GRADING AND DRAINAGE PLAN
CORONADO CHILDRENS CENTER
4106 MENAUL BLVD. NE
ALBUQUERQUE, NEW MEXICO

SHEET NO. 1
APR 13 2006
HYDROLOGY SECTION

SITE PLAN

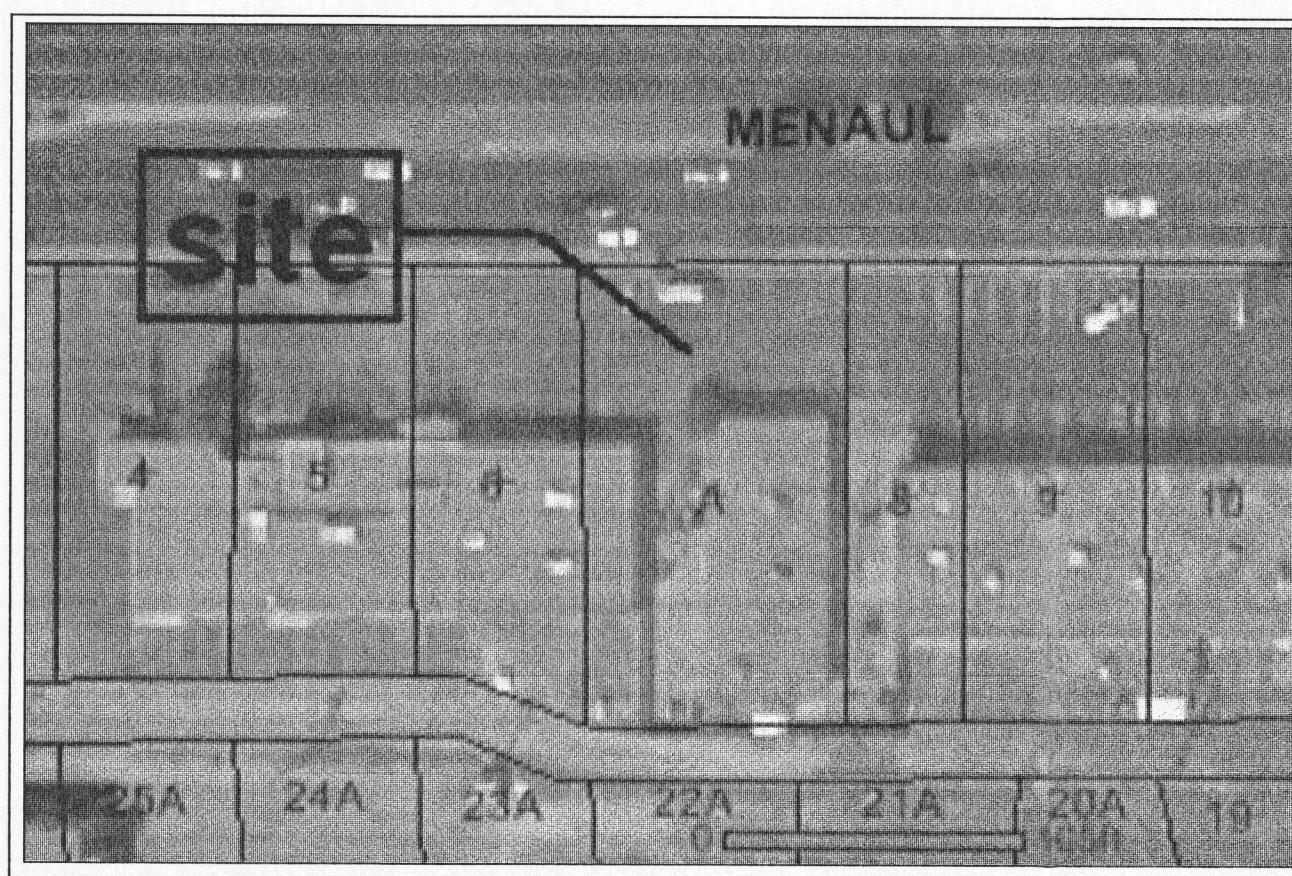
- ① PARKING CALC'S. REQ. BY ZONING.
- ② VICINITY MAP
- ③ PROVIDE SOLID WASTE APPROV.
- ④ SHOW ADA ACCESS TO SITE FROM STREET.
- ⑤ SIGNED / STAMPED ENGINEERS OR ARCHT. SEAL.
- ⑥ LABEL ALL EXISTING / PROPOSED CONST.
- ⑦ SUBMIT 4 PLANS WITH NEXT SUBMITTAL
- ⑧ LABEL WIDTH OF EXISTING SIDEWALK ALONG MENAULD

IS THIS ADA COMPLIANT?

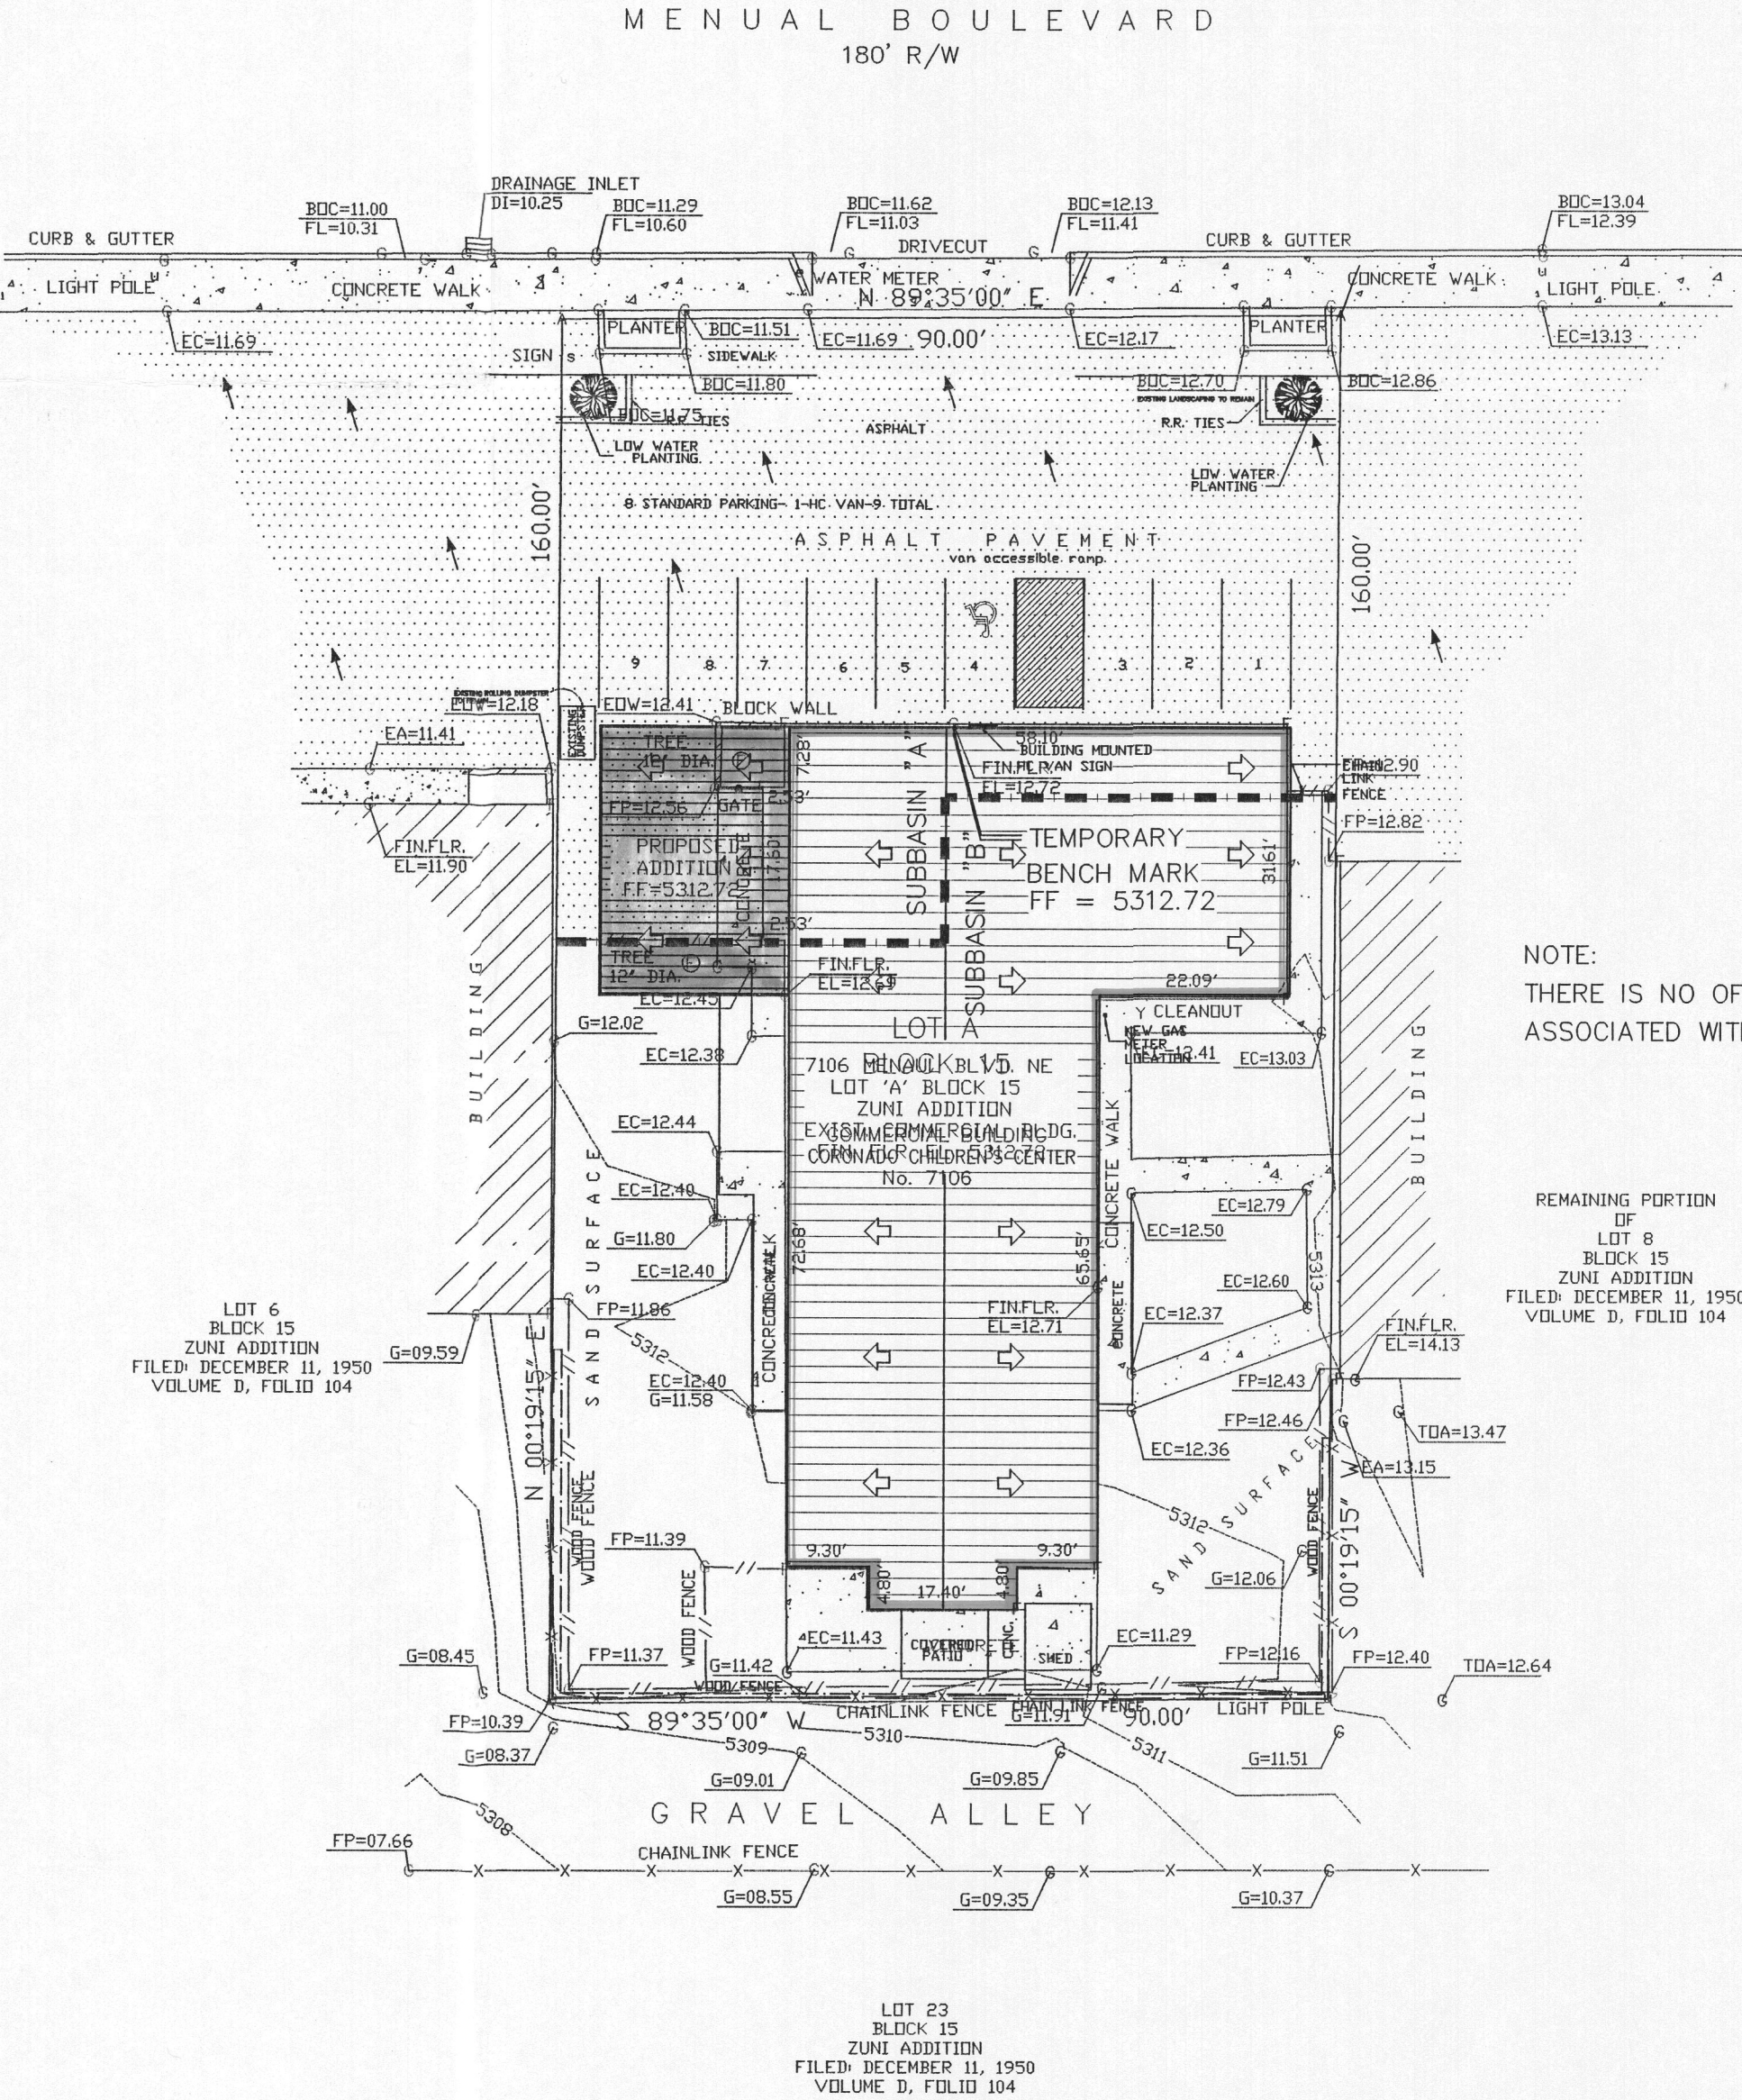
What does this mean? Where does the flow currently fall? Absorbed into sand (which covers the entire rear of the site) per Frank Lovelady
